From: Rankin, Jennivine
Sent: Friday, August 01, 2014 9:19 AM
To: ERICKSON, JEFFREY S (JERICKS@entergy.com); Hardy, Jeffery A (jhardy@entergy.com)
Subject: Request for Additional Information: Palisades Aging Management Program for Reactor Vessel Internals (ME9569)
Attachments: RAI.docx

REQUEST FOR ADDITIONAL INFORMATION REGARDING
AGING MANAGEMENT PROGRAM FOR
REACTOR VESSEL INTERNALS AT
PALISADES NUCLEAR PLANT
ENTERGY NUCLEAR OPERATIONS, INC.
DOCKET NO. 50-255

Figure A – Excerpt from Figure 14 of Reference 1

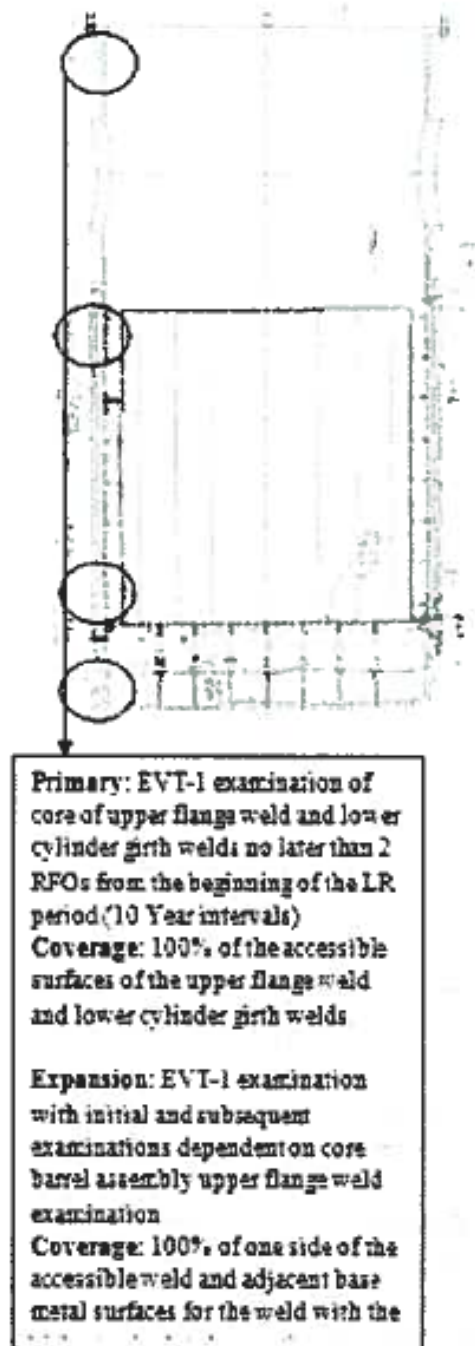
The upper left corner of Figure 14 (Reference 1), shows an elevation cross section of the PNP core support barrel and has four circled areas corresponding to portions to be inspected (Figure A below). The caption states the following:

Primary: EVT-1 examination of core of upper flange weld and lower cylinder girth welds no later than 2 RFOs [refueling outages] from the beginning of the LR [license renewal] period (ten year intervals)

Coverage: 100% of accessible surfaces of upper flange weld and lower cylinder girth welds

Figure B – PNP Lower Core Support Structure – Oval shows presumed location of weld

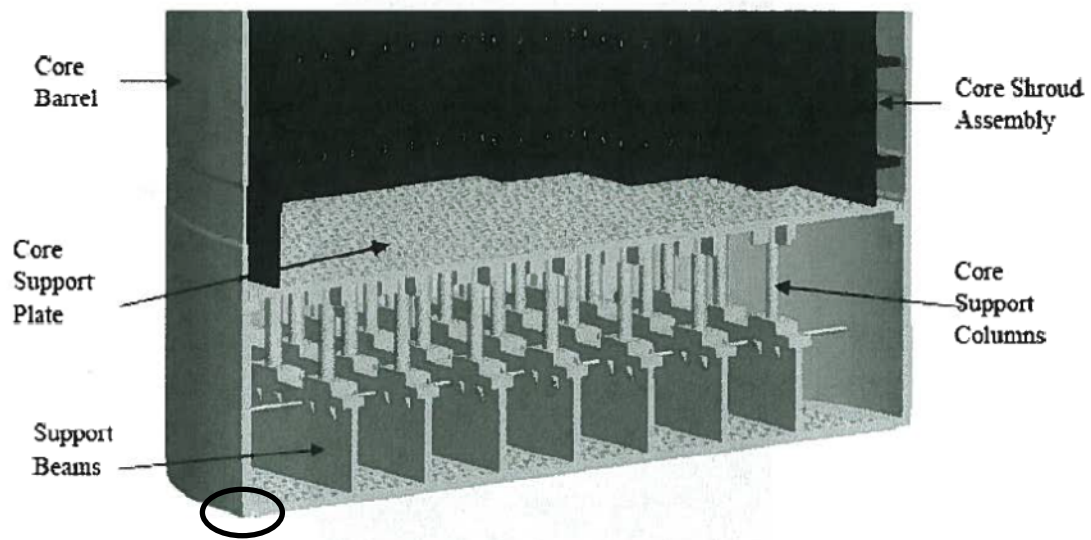
Figure 8 of Reference 1 shows a typical CE core support barrel, while Figure 9 and 10 of Reference 1 show the PNP-specific design. The PNP-specific design appears to have no core support barrel lower flange, but it appears to have a weld (Figure B below) joining the very bottom of the core support bottom to the plate that forms the bottom of the lower core support structure (the corresponding MRP-191 component designation appears to be the “Lower Support Structure – Bottom Plate, Reference 2).

1. Please confirm that the weld joining the very bottom of the core support barrel to the plate that forms the bottom of the lower core support structure (Figure B), is considered a "Core Support Barrel Lower Girth Weld," at PNP and is subject to EVT-1 visual examination as a "Primary" inspection category component.
2. Please confirm that Entergy Nuclear Operations, Inc. understands there to be an error in MRP-227-A, Tables 4-2 and 4-5 in that both the "Core Support Barrel Lower Flange Weld," and "Core Support Barrel Lower Core Barrel Flange," should have been identified as not applicable to PNP.
